DESCRIPTION  
LTR, RE OUR 2-4-76 LTR... .L FURN RESPONSES  
TO QUESTIONS ON MSL SETPOINTS AND MCPR W/  
ATCH DRAWING.....

MONTICELLO NUCLEAR GENERATING PLANT  
Docket No. 50-263 License No. DPR-22

Response to 2/4/76 Questions on MSL Setpoints and MCPR

SCRAM REACTIVITY FOR MONTICELLO CYCLE 5

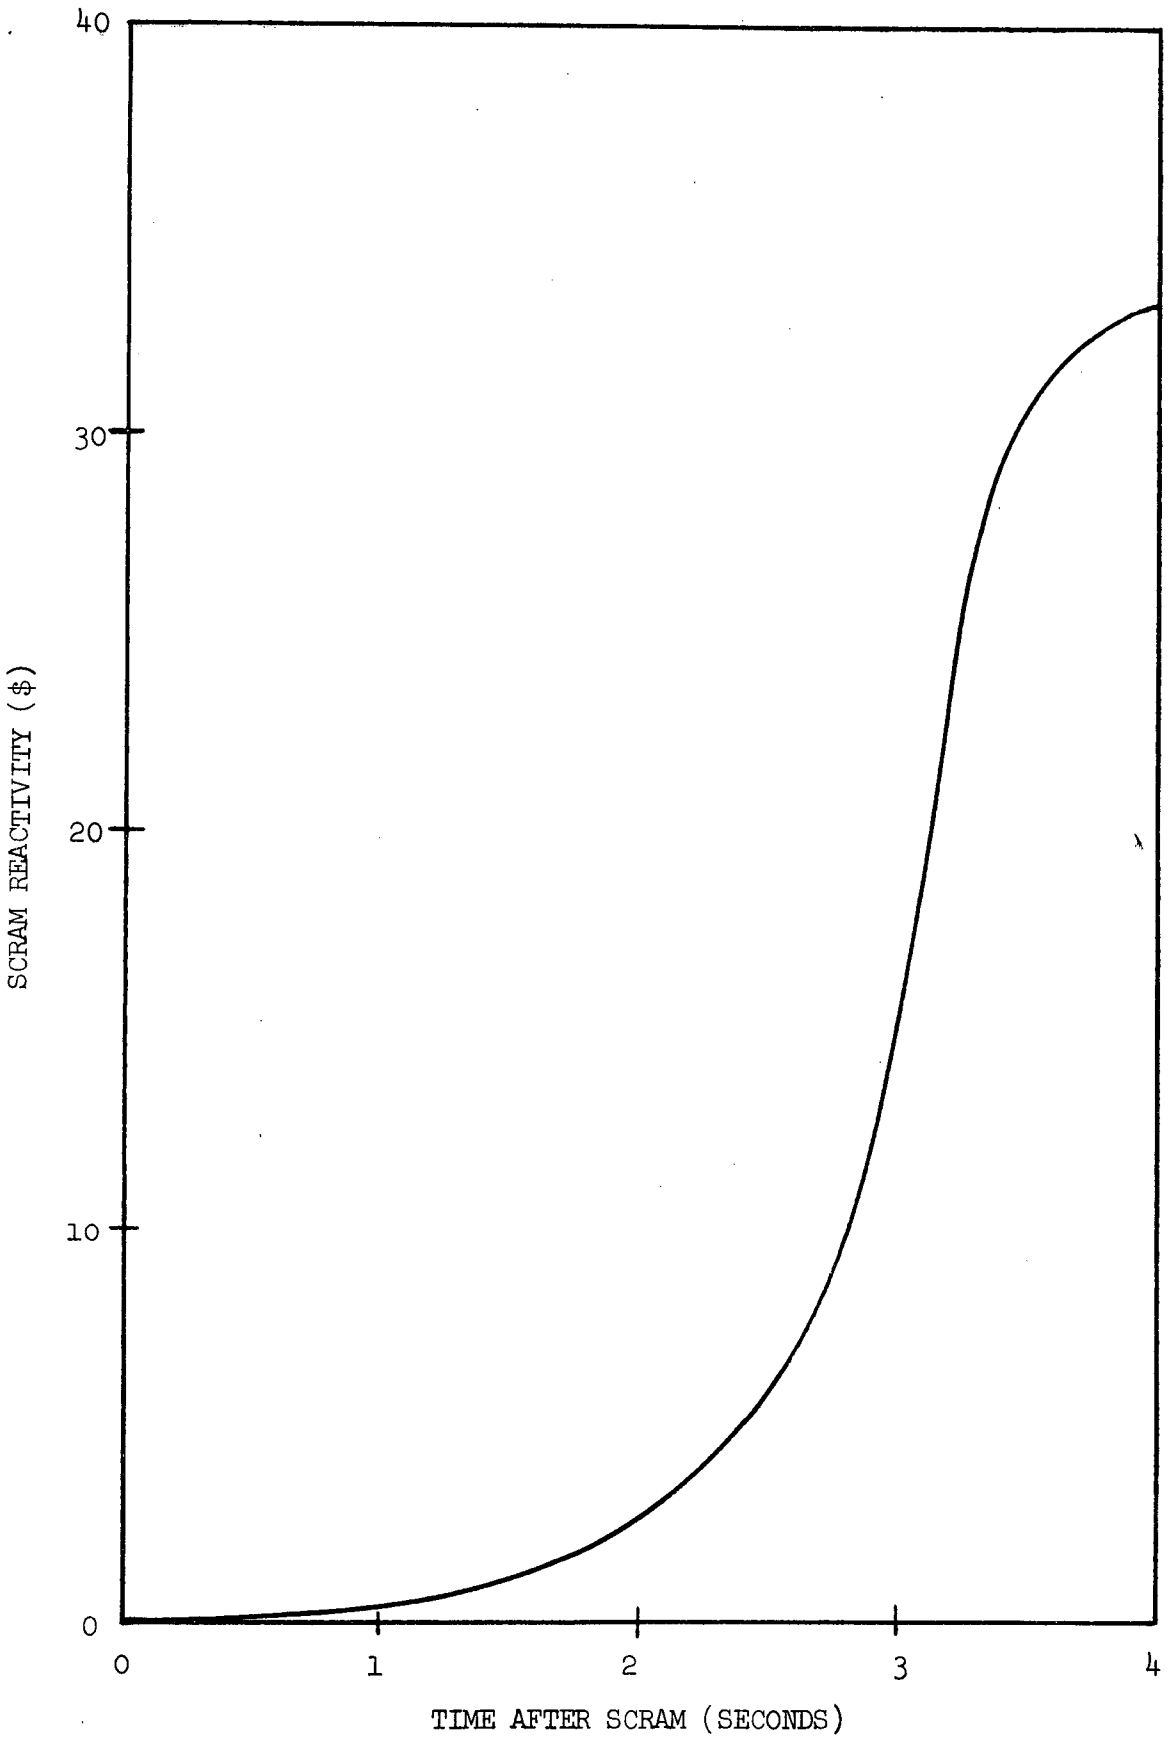
Provide the scram reactivity curve for EOC5.

The attached figure shows the scram reactivity used in the Cycle 5 analyses. This is conservatively derated to 80% of the expected value.
